PLANNING APPROVAL,
PLANNED UNIT DEVELOPMENT &
SUPPLYISION STAFF DEPORT

SUBDIVISION STAFF REPORT Date: May 20, 2004

**SUBDIVISION NAME** Coleman Cox Street Subdivision

**LOCATION** 201 Cox Street

## SITE PLAN

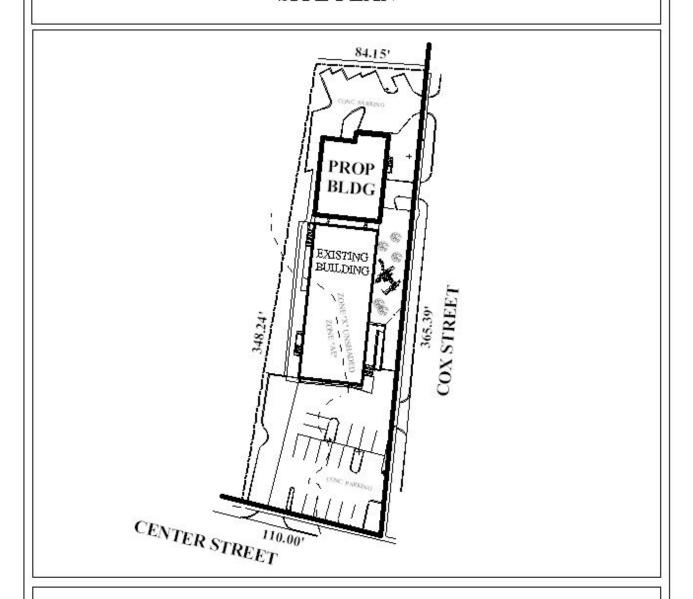
<u>COMMENTS</u> Driveway number, size, location, and design to be approved by Traffic Engineering and conform to AASHTO standards. Driveways should be widened to twenty-four feet and parking should be arranged to allow two way traffic flows.

The primary access to the site is via drives from Center Street and Cox Street that serve a parking lot located at the corner. A secondary parking facility is located at the North end of the site with access to Cox Street. There are several points of concern relating to this secondary parking facility. This facility will be significantly impacted by of the location of the new building on the site; the circulation pattern will be blocked and use of the second drive will no longer be possible. Vehicles will have to either back out of the parking facility into the right-of-way, or attempt to turn around within the site and then exit via a one-way-in drive.

Based on the site plan, it appears that there is adequate area for a parking facility that fully complies with Zoning Ordinance to be provided. To accomplish this additional paving and widening of the curb cut to allow two-way traffic would be required. Additionally, as indicated above, there is a curb cut and portions of existing paving that will no longer be useable and should therefore be removed.

The site is located at the intersection of Cox Street and Center Street; therefore, a 25' radius should be provided.

**RECOMMENDATION** Planning Approval: based on the preceding, it is recommended that this application be approved subject to the following conditions: 1) limited to the site plan submitted, as required to be revised by these approvals: 2) reconfiguration of the North parking facility to provide for two-way circulation and drive; 3) removal of all paved areas that will no longer be part of the active parking and circulation facilities; 4) elimination of any inactive curb cuts, including removal of paved surfaces and installation of fill and landscape materials; 5) completion of the subdivision process; and 6) full compliance with all municipal codes and ordinances.

**Planned Unit Development:** based on the preceding, it is recommended that this application be approved subject to the following conditions: 1) limited to the site plan submitted, as required to be revised by these approvals: 2) reconfiguration of the North parking facility to provide for two-way circulation and drive; 3) removal of all paved areas that will no longer be part of the active parking and circulation facilities; 4) elimination of any inactive curb cuts, including removal of paved surfaces and installation of fill and landscape materials; 5) completion of the subdivision process; and 6) full compliance with all municipal codes and ordinances.

**Subdivision:** the plat meets the minimum requirements of the Subdivision Regulations and is recommended for Tentative Approval subject to the following conditions: 1) dedication of a 25' radius at the intersection of Cox Street and Center Street; 2) elimination of any inactive curb cuts, including removal of paved surfaces and installation of fill and landscape materials; and 3) placement of the required 25' minimum building setback line along all street frontages.
